**State of Alaska  
Department of Fish and Game  
Sportfish Division**

**Nomination Form  
Anadromous Waters Catalog**

Anadromous Waters Catalog Number of Water Body 247-60-10253 (-2001)

Name of Water Body Unnamed (tributary of \*Tidewater Slough)  USGS Name  Local Name

Map  
#2

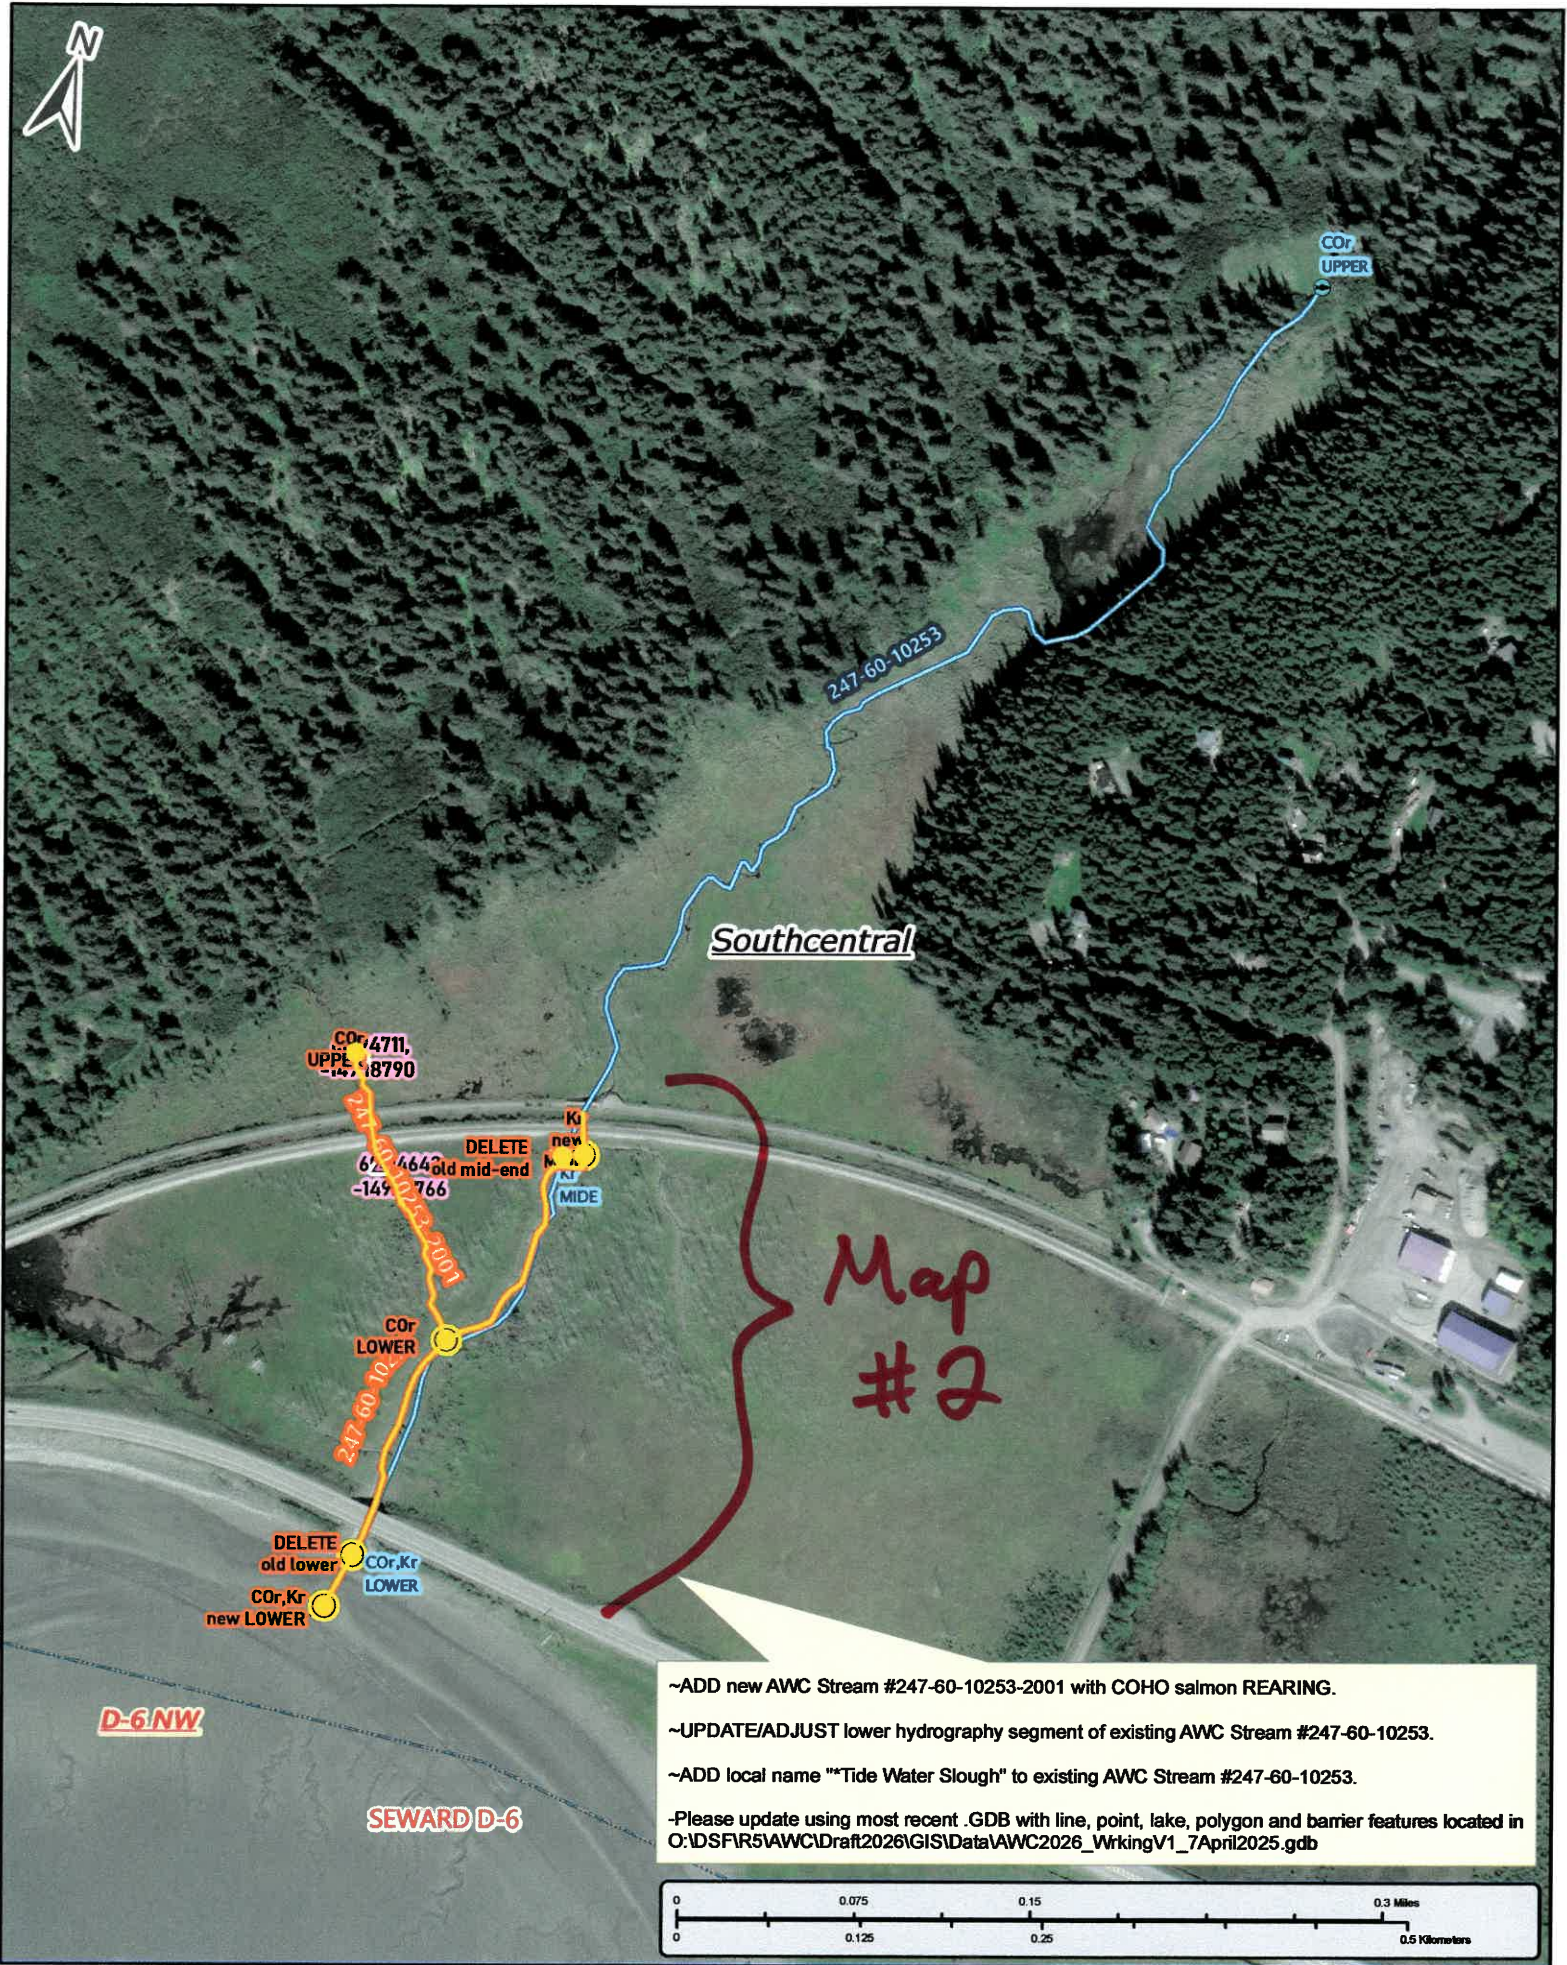
62, 464, 149  
-149, 2766  
DELETE  
old mid-end

Ki  
new  
Kr  
MIDE

DELETE  
old lower  
COR, Kr  
new LOWER  
COR, Kr  
LOWER

~ADD new AWC Stream #247-60-10253-2001 with COHO salmon REARING.

~UPDATE/ADJUST lower hydrography segment of existing AWC Stream #247-60-10253.

~ADD local name ""Tide Water Slough" to existing AWC Stream #247-60-10253.

Map #3

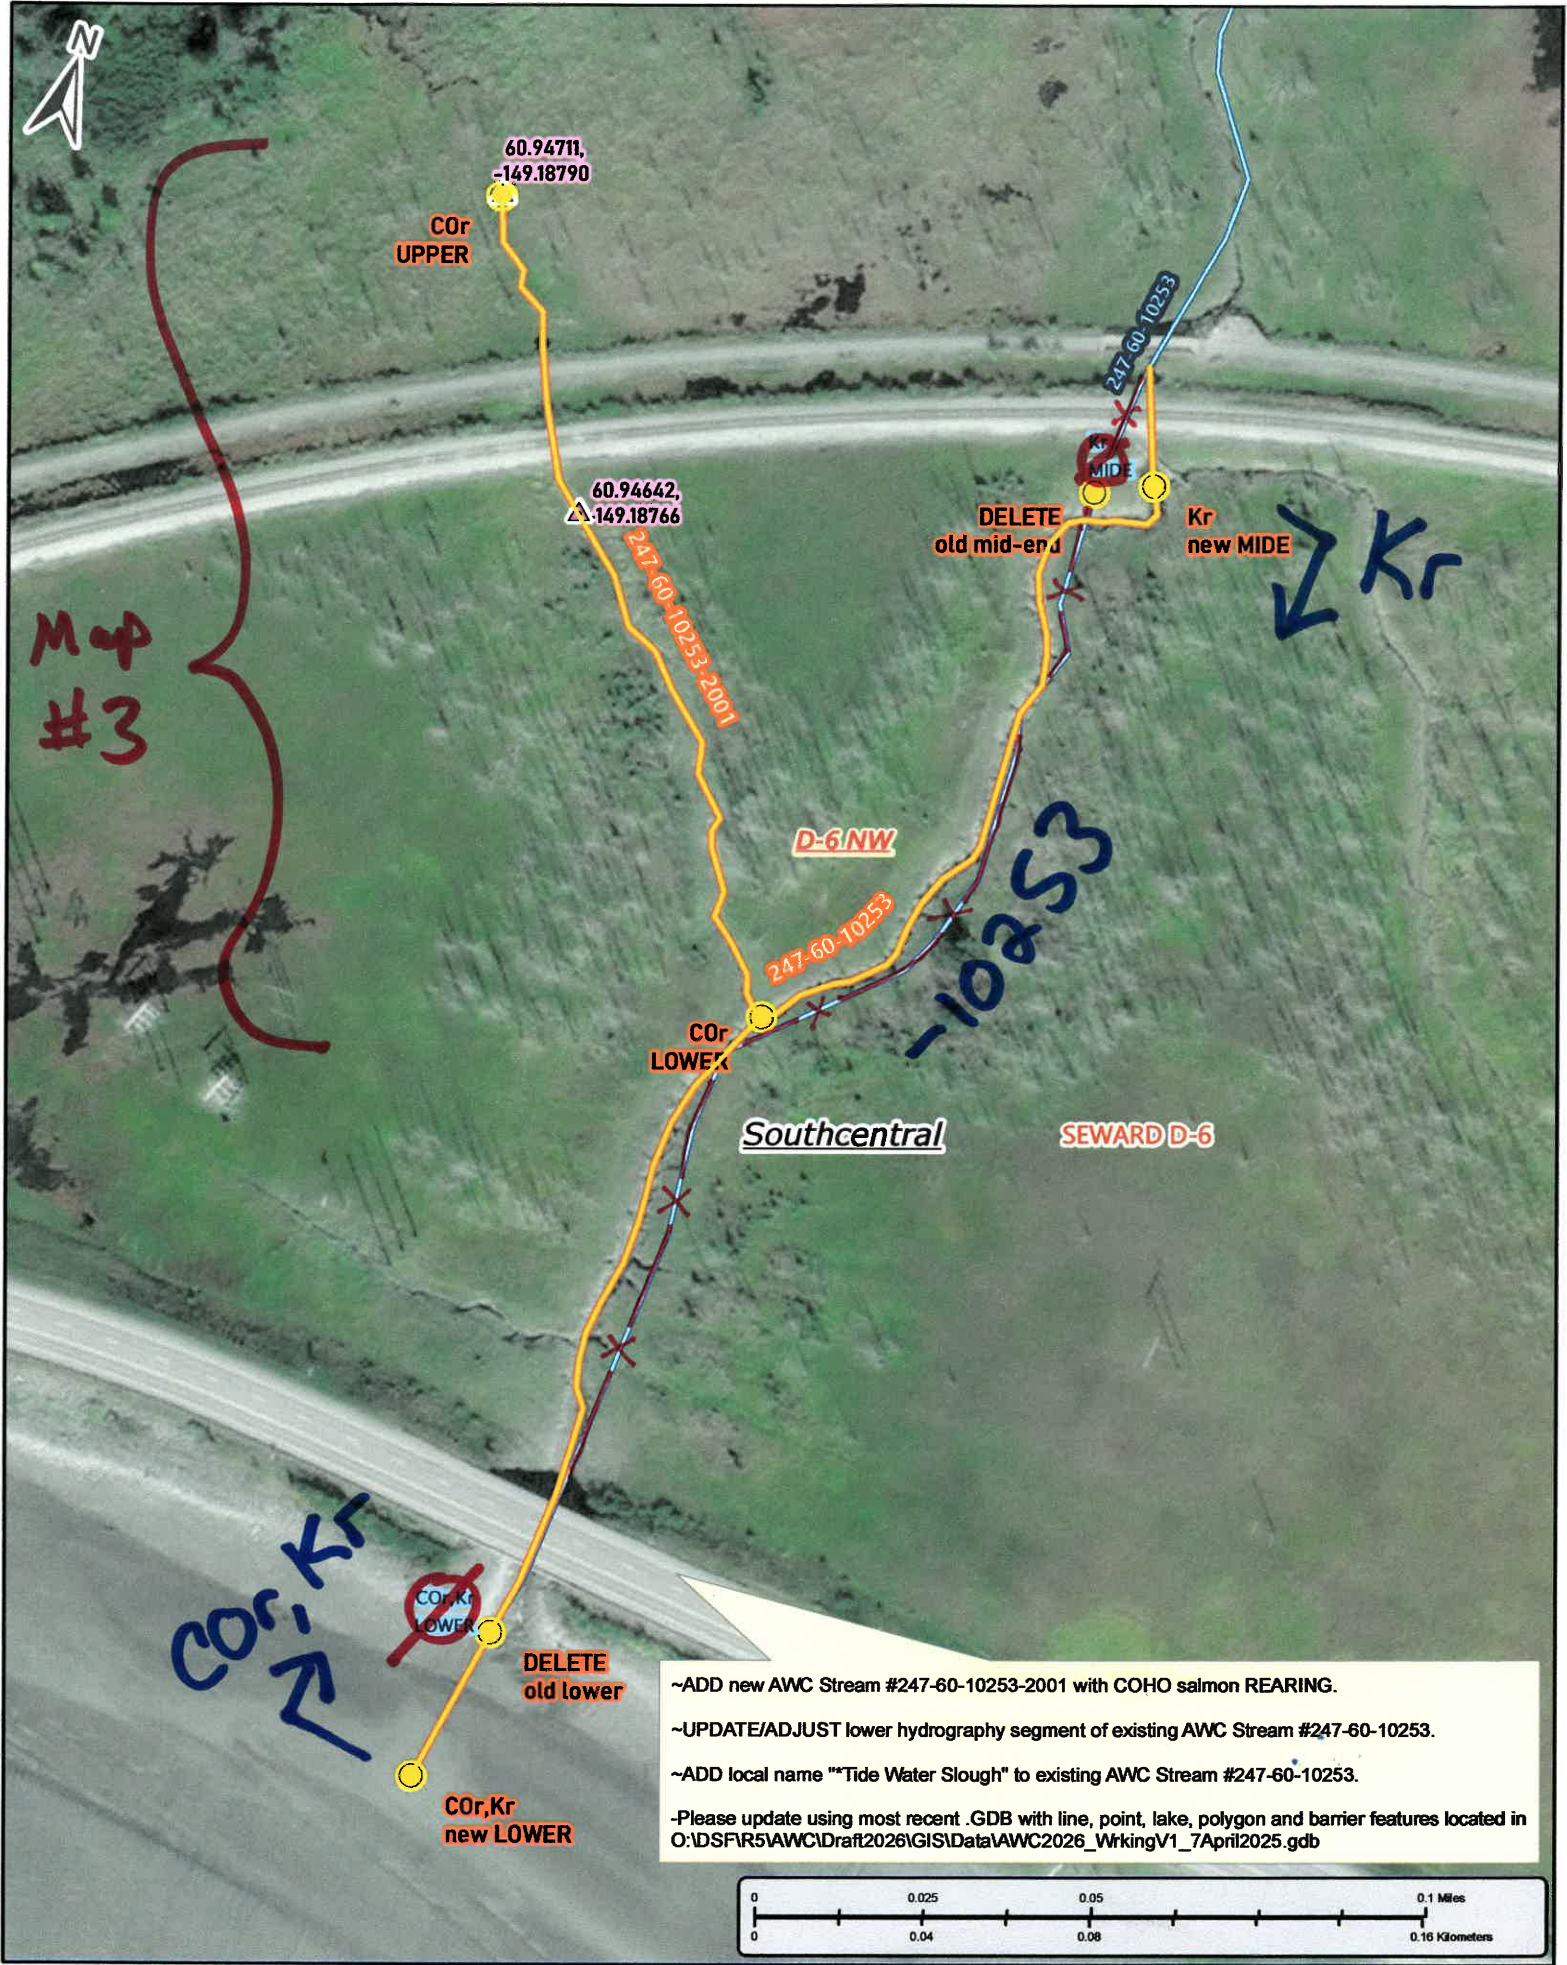
- ~ADD new AWC Stream #247-60-10253-2001 with COHO salmon REARING.
- ~UPDATE/ADJUST lower hydrography segment of existing AWC Stream #247-60-10253.
- ~ADD local name ""Tide Water Slough" to existing AWC Stream #247-60-10253.
- ~Please update using most recent .GDB with line, point, lake, polygon and barrier features located in O:\DSFR5\AWC\Draft2026\GIS\Data\AWC2026\_WrkingV1\_7April2025.gdb

~~KP  
MIDE~~

DELETE  
old mid-era

Kr  
new MIDE
